Marma Composite Ltd. (extension 2)

3rd November 2020

1. Admin Building (B+G+2)
2. Security Building: (G+1)

Observations

Passage from stair to roof slab

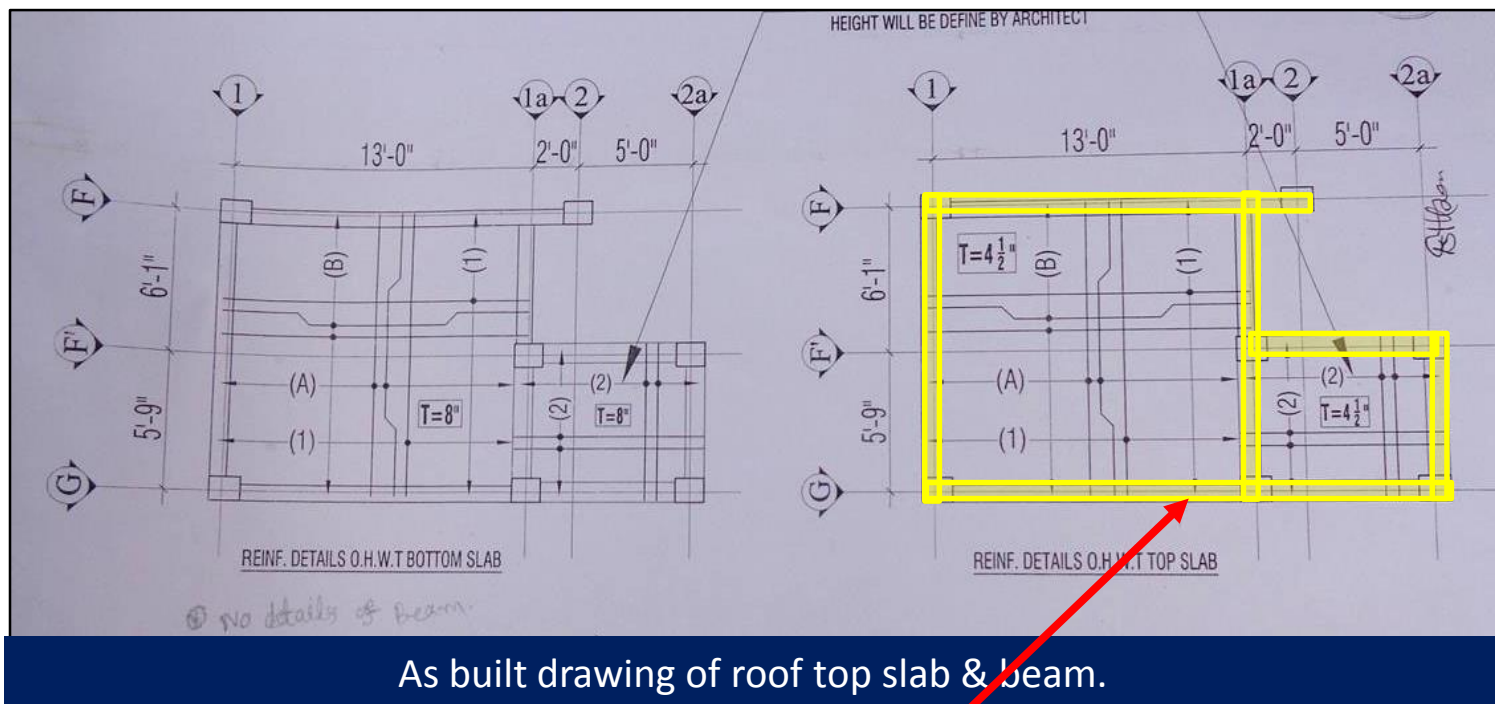
Roof plan does not match with the as-built drawing. A Passage was found from stair to floor. But in roof plan layout of as-built drawing the passage has not been shown. Factory engineer is required to survey the structures and prepare as-built drawings.

Roof top beam-slab

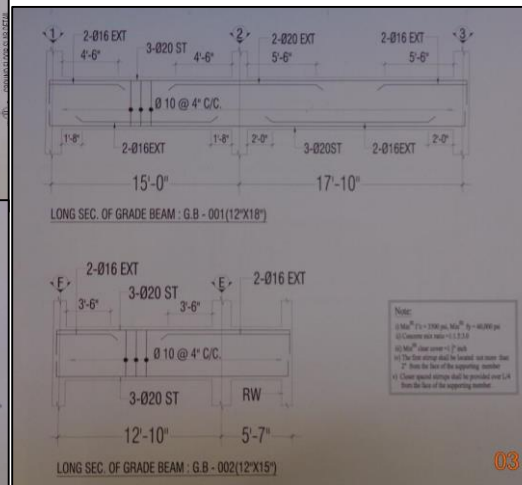
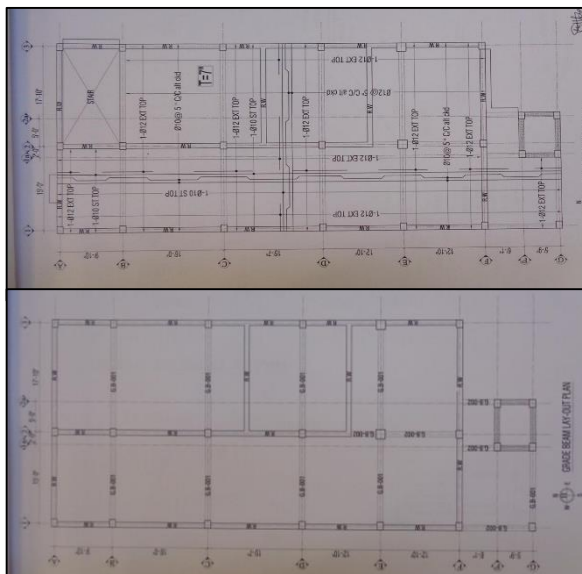
The details of the roof top beam over the stairs & lift core has not been provided in as built drawing. Factory engineer is required to survey the structures and prepare as-built drawings.

Figure 3-4: SDL in ETABS on 2nd floor (unit = psf)

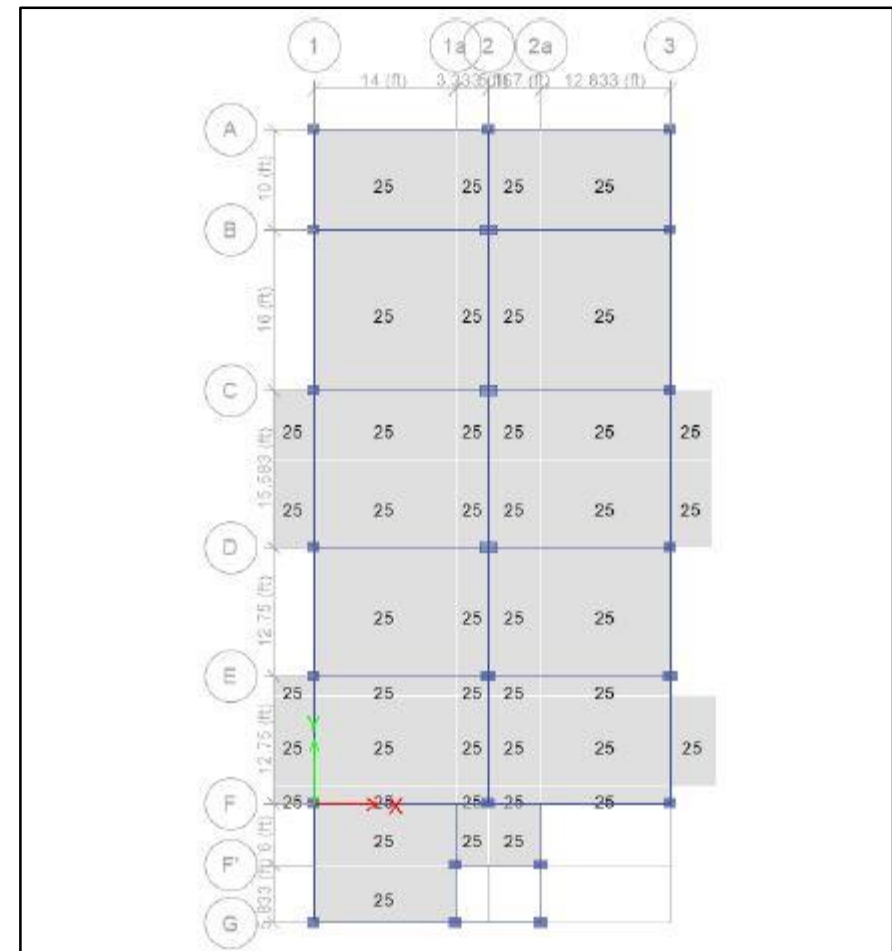
Floor Finishes was found 85 mm at 2nd floor.

Super imposed Dead Load was found 25 psf.

During inspection, Floor finishes was found 85 mm. In the software analysis, 25 psf (1.2 kPa) has been considered as super imposed dead load which is equivalent to 50mm floor finishes. Factory engineer to revised the analysis and design report for actual floor finish loads.

2nd floor Layout Plan. Proposed for gym at marked area.

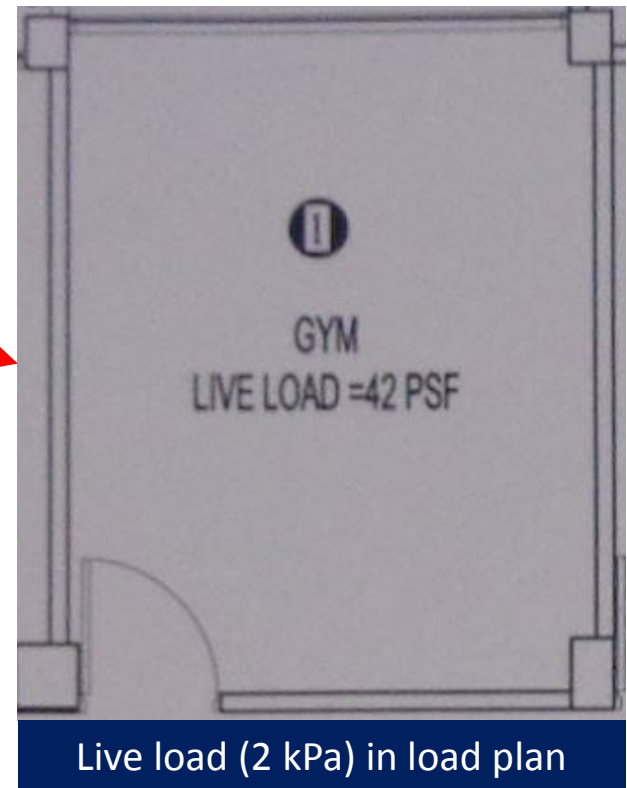
Gymnasium has been proposed at 2nd floor at marked area. The live load of that area has been considered 42 psf (2 kPa). As per BNBC, minimum loading 3 Kpa is required for the fixed seat gymnasium. Factory engineer is required to update the floor loading plan, software-based analysis and design report following BNBC loading requirement.

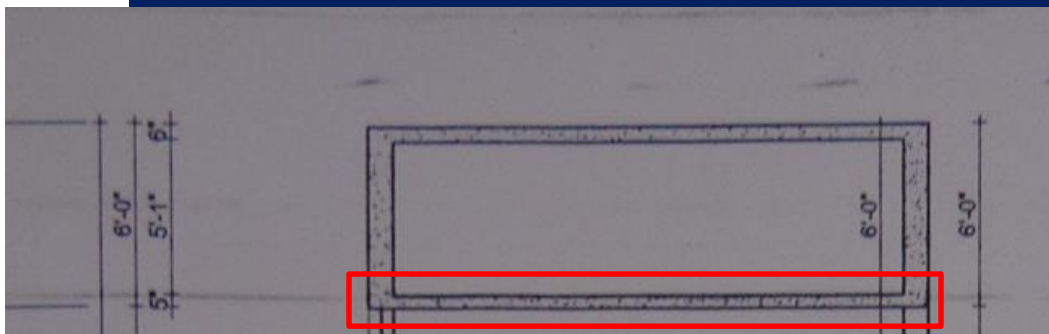
In design report, adequacy of the retaining wall has not been mentioned.

Bottom slab of the water tank is 125mm

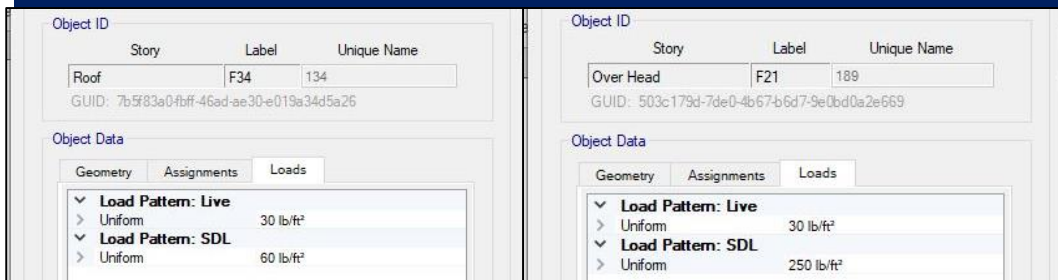
Dead load of the bottom slab has not been assigned in FEA model.

As per BNBC, every building or structure designed shall have its design documents prepared in accordance with the provision of Section 1.9.1. The design document shall include a design report, and a set of structural drawings, which shall be prepared in compliance with section 1.9.1.1 and section 1.9.1.2 as per BNBC. Revise the software-based analysis model, design report and load plan following BNBC requirements.
